ARCHITECTURAL REVIEW BOARD
MEETING OF APRIL 26, 2022 - 4:30 P.M.
BRIGHTON TOWN HALL

FRONT ELEVATION - PROPOSED

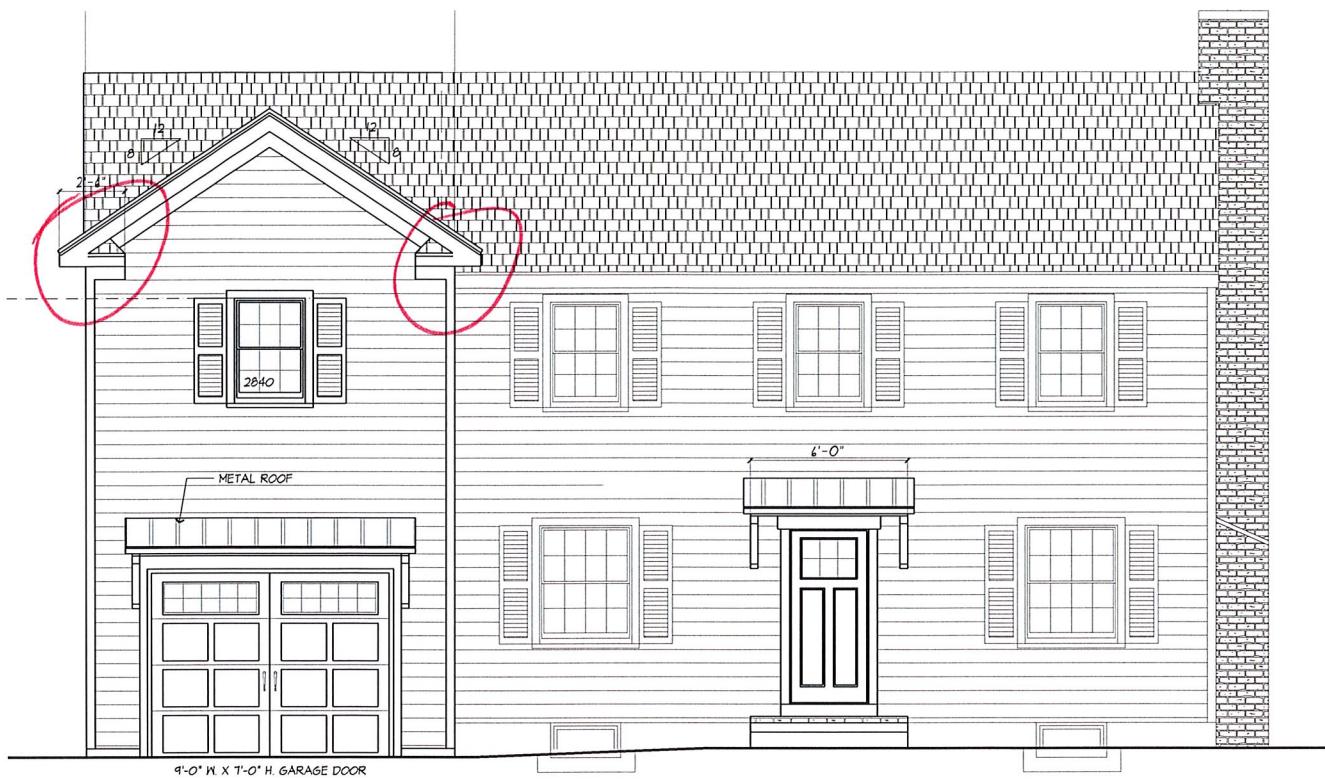
- Provide for additional windows on east façade to reduce blank space and consider east façade composition.
- Extend eaves on left roof gable to tie in with the surrounding eaves.
- Recommend extending the eaves on the front gable to align with existing eave.
- See attached sketch.
